# UNITED STATES PATENT AND TRADEMARK OFFICE

APPLICATION NO.	FILING DATE	FIRST NAMED INVENTOR	ATTORNEY DOCKET NO.	CONFIRMATION NO.
09/963,577	09/27/2001	Ryoichiro Uehara	05711.0122	9686

<b>Office Action Summary</b>	Application No. 09/963,577	Applicant(s) UEHARA ET AL.	
	Examiner James R. Brittain	Art Unit 3677

## DETAILED ACTION

【図1】

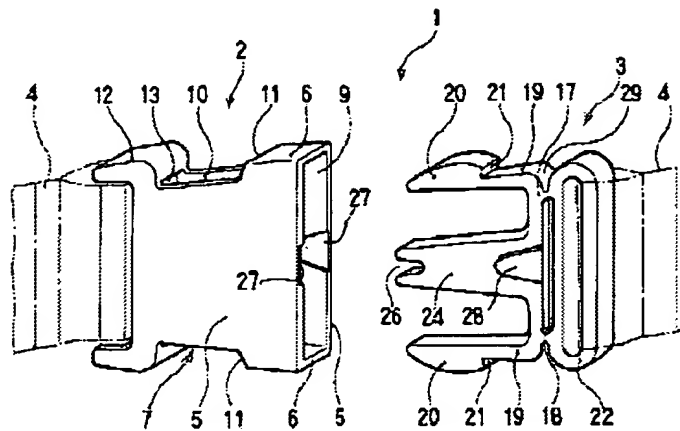
JP 8-131215 (figures 1, 2, 6, 13, 14, 16, 17) teaches a buckle comprising a female body 2 formed with a flat housing and a male body 3 having flexible insertion legs 20 which are engaged with each other by insertion, each of the female body and the male body having a front surface, a rear surface, and right and left side faces, and having butting portion including straight portions 18 and a convex portion 28 formed on the front surface of the male body and a concave portion 27 with straight portions defined by the edge of the mouth of the female body on the inside surface of the front face of the female body 2, wherein the concave 27 and convex 28 portions are formed at a center of the butting portion sandwiched by the straight portions 18 on the male body and the corresponding straight portions of the female body, the convex portion 28 in the butting portions protrudes in a wedge-shaped form with a rounded narrowed leading edge while the concave portion 27 is dented with the inlet expanded, the female and male bodies are thereby formed closely in contact at the butting portions, a guide 24 is protruded linearly from a center of a front end of the convex portion 28 of the male body, and partition pieces 16, 25 for

As to claim 3, JP 8-131215 shows in figure 1 the concave and convex butting surfaces formed on both front and rear surfaces of the male and female bodies.

In regard to claim 4, JP 8-131215 shows in figure 1 the concave and convex butting surfaces sandwiched between straight butting portions formed on both front and rear surfaces of the male and female bodies. Claim 4 requires butting straight or linear-form butting portions on two opposite sides and the convex and concave portions on one side. JP 8-131215 shows this. Claim 4 is silent on prohibiting other butting configurations such as convex and concave on the opposite surface. There are no limitations in claim 4 to prohibit convex and concave portions on both sides.

As to claim 12, the side view shown in figure 1 shows the convex portion and straight portions being notched to a one level lower stepped portion which fits into the female body so as to be overlapped thereby.

【図13】

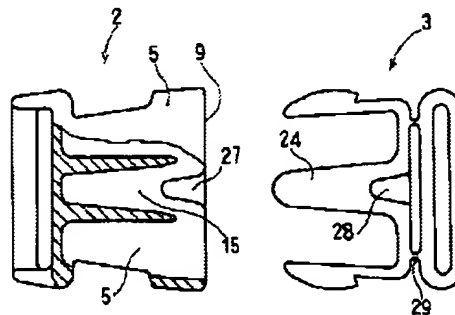
As to claim 7, JP 8-131215 shows the concave portion of the female body and the convex portion on the male body in figures 1, 13, 14, 16, and 17.

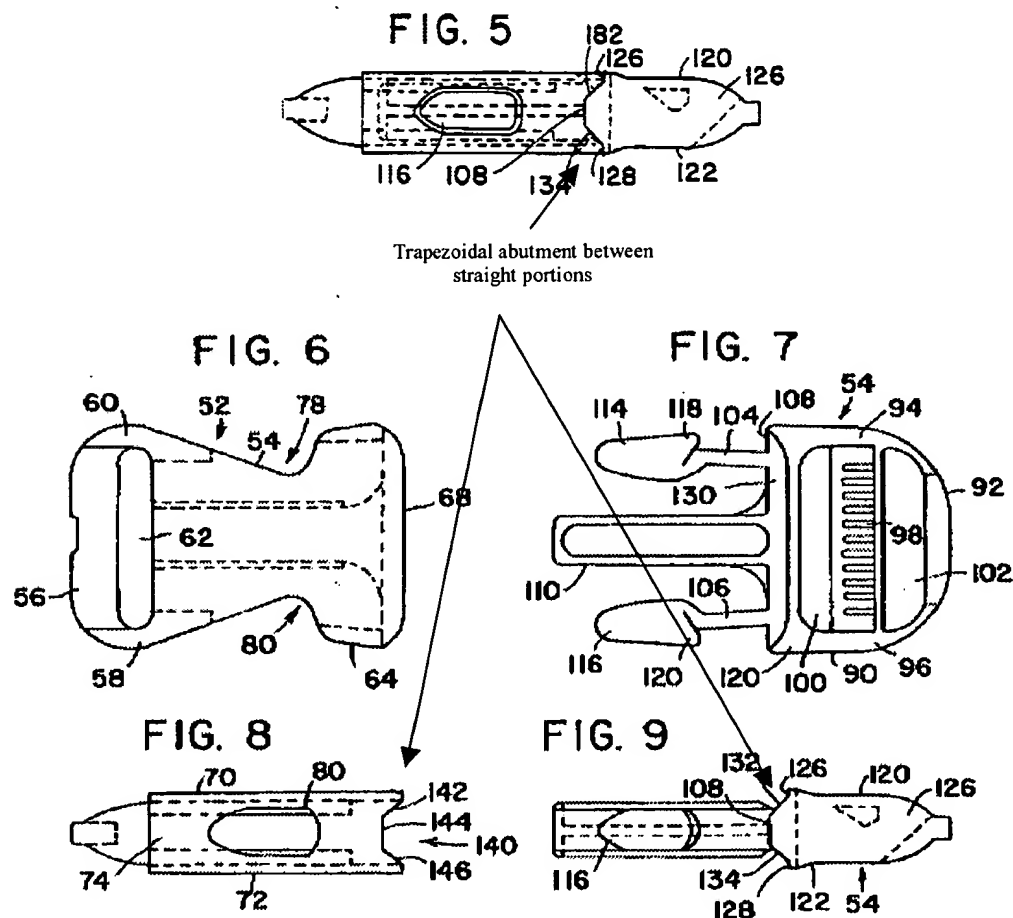
The difference is that the convex portion is not trapezoidal and the concave portion does not extend through the thickness of the front face of the female body so as to exist on the front surface. However, Krauss (figures 5-9) teaches a buckle similar to JP 8-131215 and further suggests the use of a trapezoidal butting guide 132, 134, 108 positioned on opposite side faces of the male body fitting into a cooperating recesses 142, 144, 146 on side faces of the opening of the female body that extend completely through the side faces so as to provide a geometry well known in buckles to provide stable interengagement between the male and female bodies.

As the JP 8-131215 buckle is designed to have butting convex and concave surfaces on the male and female bodies, respectively, so as to inherently interlock the male and female bodies together at the mouth of the female body against relative lateral movement and it would be advantageous to have the lateral torsional loads well distributed across the front faces of the male and female bodies to the side faces while maintaining square alignment during insertion and preventing lateral movement, it would have been obvious to modify the buckle of JP 8-131215 so that the butting portions are trapezoidal in view of Krauss (figures 5-9) teaching the use of a trapezoidal butting guide 132, 134, 108 on the male body fitting into a cooperating

recess 142, 144, 146 extending completely through a minor face of the opening of the female body so as to provide a geometry well known in buckles to provide stable interengagement between the male and female bodies so that torsional forces can be well distributed while providing sure guidance and preventing side to side movement.
